**MEMORANDUM**

**TO:** District of Columbia Board of Zoning Adjustment  
**FROM:** Karen Thomas, Case Manager  
*JL* Joel Lawson, Associate Director Development Review  
**DATE:** July 13, 2018

**SUBJECT:** FMBZA Case # 19788 Application of the Kingdom of Norway pursuant to 11 DCMR Subtitle X § 201.8 for renovation of and addition to its chancery.

**Garden View – Existing and Proposed**

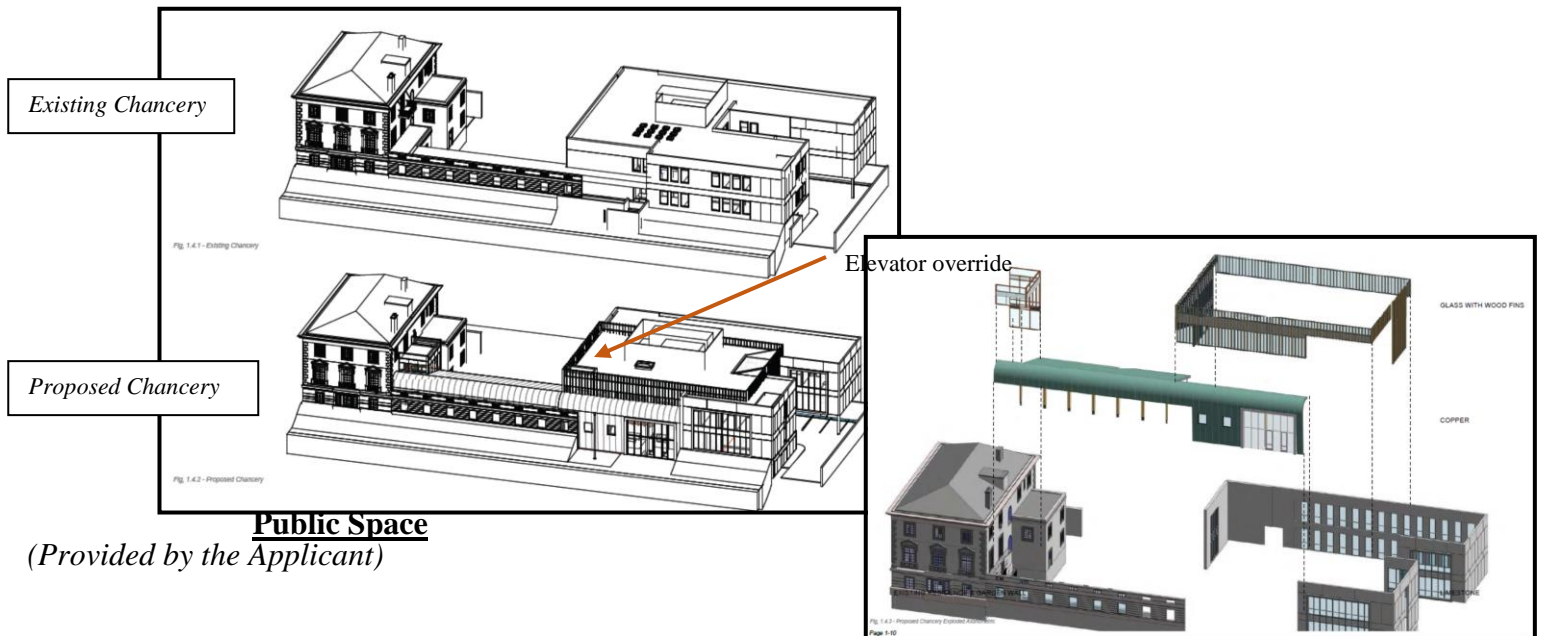
**Lot Occupancy: D § 704:** Maximum: 40%: Existing: 41.7%: Proposed: 45.4%  
The existing lot occupancy at 41.7% would be increased to 45.4% by the addition of the approximately 4,272 square foot addition as a garden room, which would connect the residence to the chancery. The existing enclosed garden would be reconfigured to extend and enhance proposed program space into the exterior. Further, there would be an addition of an accessible entrance to the main chancery building lobby from 34th Street.

Due to the locations of the proposed additions, neither should have an undue impact to the light and air to neighboring property, nor should they create privacy concerns for the abutting neighbors to the north or west of the site, which are well screened by landscaping and vegetation. The garden room area would serve in part as function space for events averaging around 40 guests at a time. The number of events (approximately 100 per year) is not anticipated to increase due to the addition.

Therefore, the proposed additions should not create an adverse impact on the surrounding neighborhood to harm the public good or the intent of the Regulations. OP supports the requested relief.
